DEVELOPMENT REVIEW BOARD

Planning Dept. - Major Case Comments

Project Number: PR-2018-001346

Application Number: SI-2022-00184
Project Name: Whataburger at San Pedro Drive NE and Alameda Boulevard NE

A2 EAST ELEVATION - MAY 21st @ 4:00 P.M.
SCALE 1/4" = 1'-0"

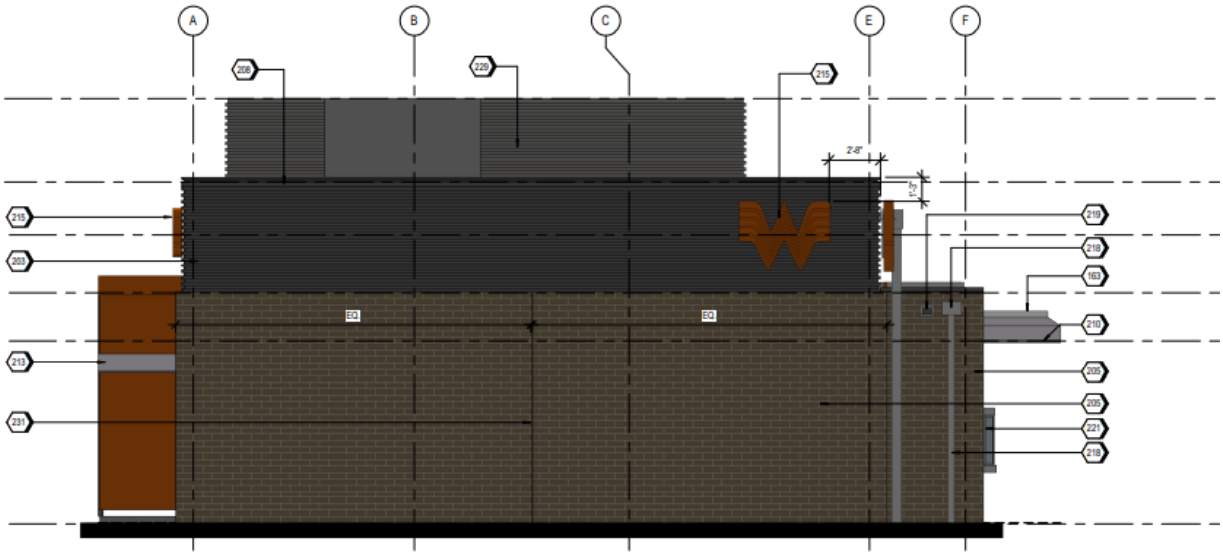
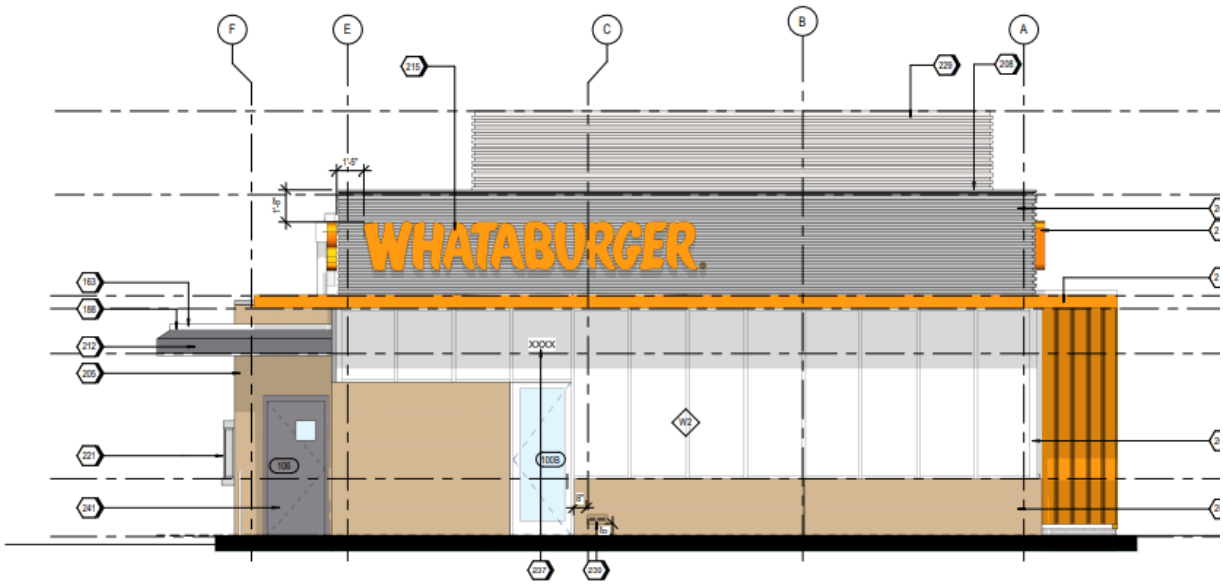
- The Climatic and Geographic Analysis is thorough and informative. Could there be any consideration to reorient the building to have the dining room windows facing the east instead of the west for a preferred solar orientation and better building performance? The orientation of the dining room to the east would provide a preferable occupant experience in terms of lighting and capturing views of the Sandia mountains.
